Access Compliance Report

Public Rights-of-Way

(Curb Ramps)

Intersection ID: 9228	Main Street: FAIRMONT_ST	Cross Street: RENNER_ST	Location: SW
ADA ID: 831FF50BD325	Ramp Type: PerpDiag	Initial Pass/Fail: Fail	Overall Compliance: No
		Severity Score: 12.5

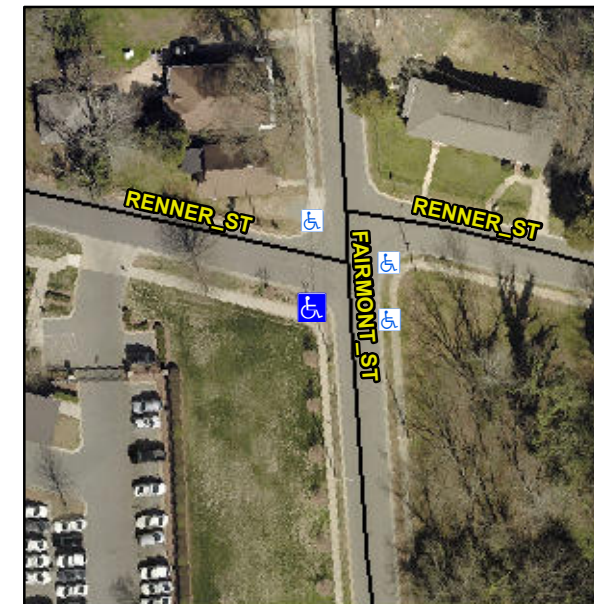
Not Found, R304.2.2

Compliance	Description	Data	Compliance	Description	Data
N/A	Ramp Length (in)	26.0	No	Ramp Slope (%)	11.1
Yes	Ramp Width (in)	48.0	Yes	Ramp XSlope (%)	0.2
N/A	Flare Type LT	N/A	N/A	Flare Type RT	N/A
N/A	Flare Slope LT (%)	N/A	N/A	Flare Slope RT (%)	N/A
N/A	Flare Traversable LT?	N/A	N/A	Flare Traversable RT?	N/A
N/A	Landing Length (in)	N/A	N/A	DWS Provided?	N/A
N/A	Landing Width (in)	N/A	N/A	DWS Contrast?	N/A
N/A	Landing Slope (%)	N/A	N/A	DWS Length (in)	N/A
N/A	Landing X Slope (%)	N/A	N/A	DWS Full Width?	N/A
N/A	Landing Curb? (Y/N)	N/A	N/A	DWS Offset (in)	N/A
N/A	Shared Landing?	N/A			
N/A	Gutter Ponding?	N/A	N/A	Gutter Slope (%)	N/A
N/A	Gutter Lip Ht (in)	N/A	N/A	Gutter X Slope (%)	N/A
N/A	Painted X Walk1?	No	N/A	Painted X Walk2?	No
	X Walk 1 Direction	To E		X Walk 2 Direction	To N
N/A	X Walk 1 Width (in)	N/A	N/A	X Walk 2 Width (in)	N/A
	X Walk 1 Slope (%)	1.8		X Walk 2 Slope (%)	1.6
	X Walk 1 X Slope (%)	2.2		X Walk 2 X Slope (%)	2.3

Remove & Replace Curb Ramp With Two New Directional Ramps or Equivalent.
